: Soil and Water Investigation Work Plan - Addendum

Dublin Auto Wash
7240 Dublin Boulevard
Dublin, California
Fuel Leak Case No. RO0000304

Proposed Boring and Well Locations (Revision 1)

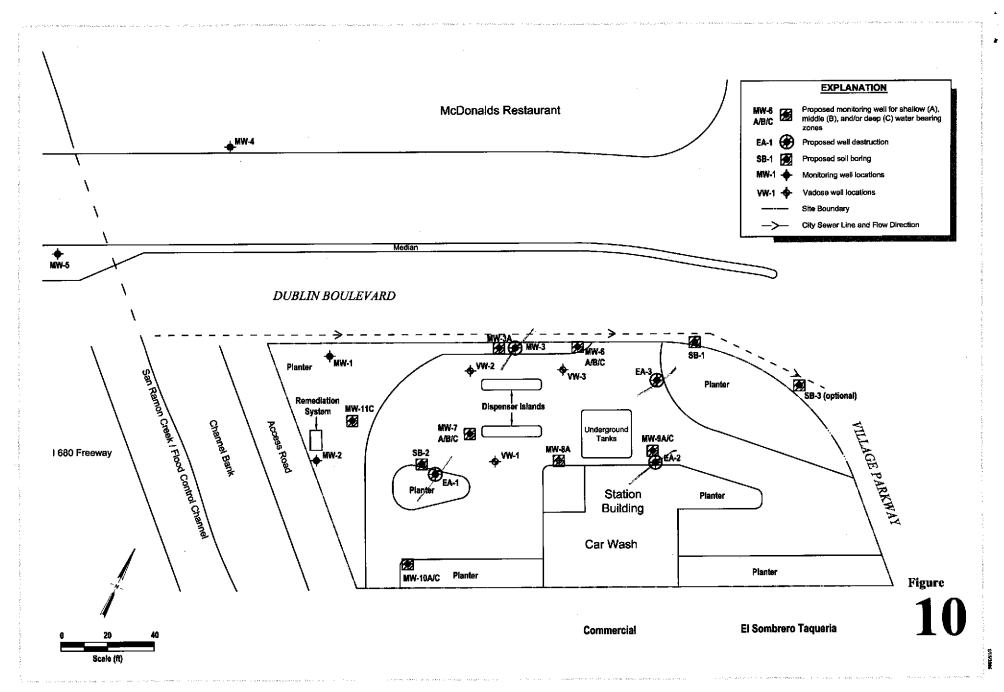
Based on our discussion of the site conditions and regulatory concerns, Pangea recommends installing four more wells than proposed in the work plan. Pangea recommends installing two monitoring wells in the middle water-bearing zone (MW-6B and MW-7B), which had originally been presented as 'optional' wells. Pangea also proposes two additional monitoring wells in the deeper water bearing zone (MW-9C and MW-10C). These new additional wells will facilitate more complete assessment of the site subsurface in the vertical and lateral directions, and could assist with any future feasibility testing or site remediation. The proposed well locations from the work plan and this addendum are shown on the attached and revised Figure 10. These wells will be screened and installed as discussed by the work plan for middle and deeper water-bearing zone wells.
